PR/1382/22

Record of Executive Business and Chief Executive's Order

Reg. Reference: SD22A/0268 **Application Date:** 09-Jun-2022
Submission Type: Additional **Registration Date:** 06-Oct-2022
Information

Proposed Development: Extension to the front and side of the existing storage warehouse building (314.00sqm) with ancillary office space and new exterior illuminated signage to front and side and ancillary site works.

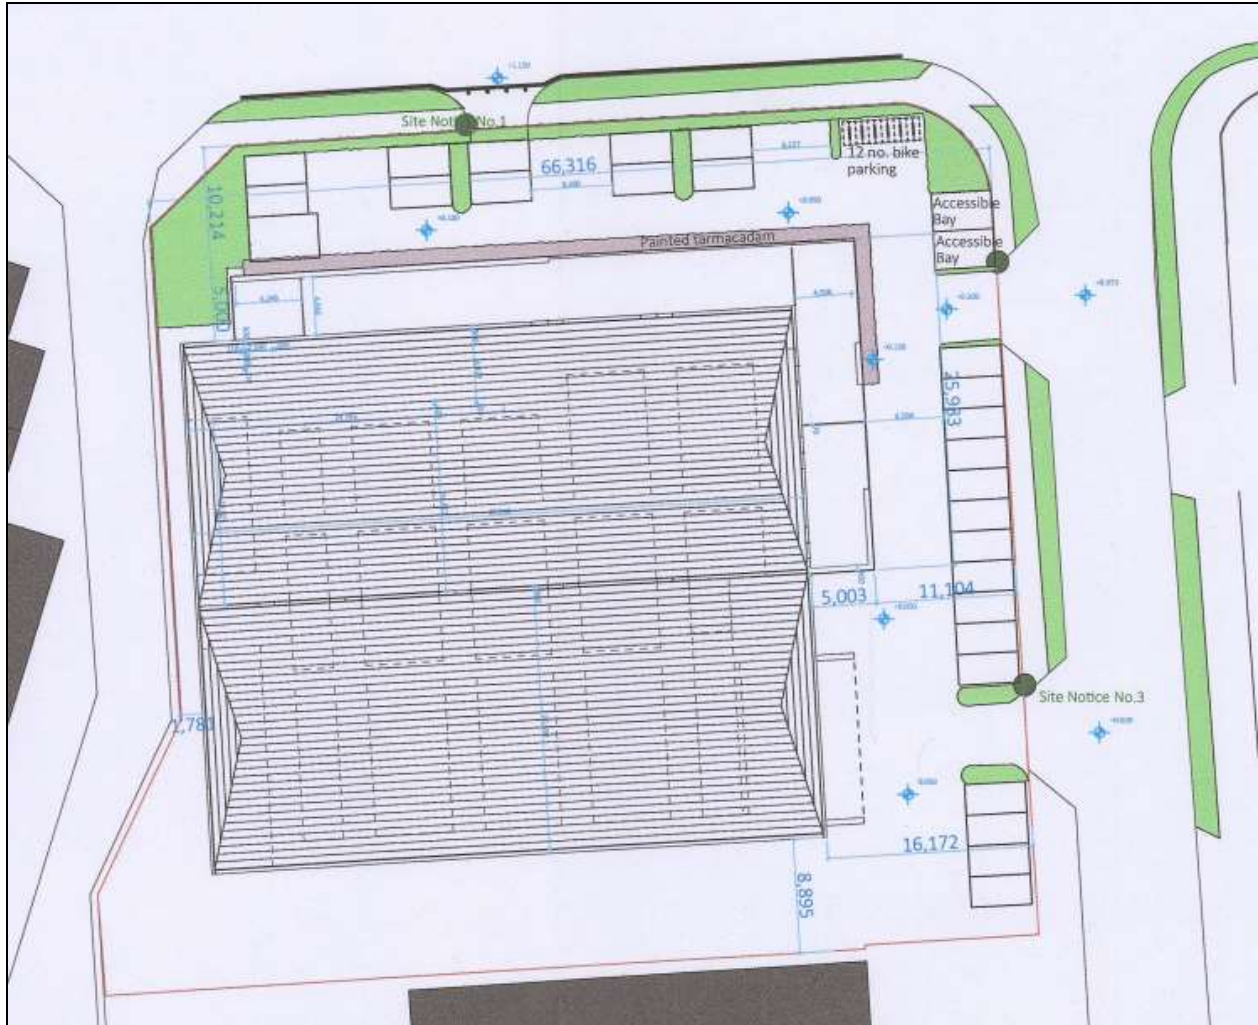
Roads Related Additional Information Requested by SDCC:

2.(1). The applicant is requested to submit a revised layout not less than 1:200 scale showing:

- a. the provision of bollards and double yellow lines in the closed northern access point to prevent vehicles parking.*
- b. the provision of 2 No. mobility impaired car parking spaces.*
- c. a minimum reversing distance of 6m for all car parking spaces.*
- d. The provision of a minimum of 12 No. bicycle parking spaces in the interest of sustainable transport and to comply with the SDCC Development Plan 2022-2028 Table 12.23: Minimum Bicycle Parking/Storage Rates*

Roads Department Assessment:

SDCC Roads Department is satisfied with the applicant's revised layout.
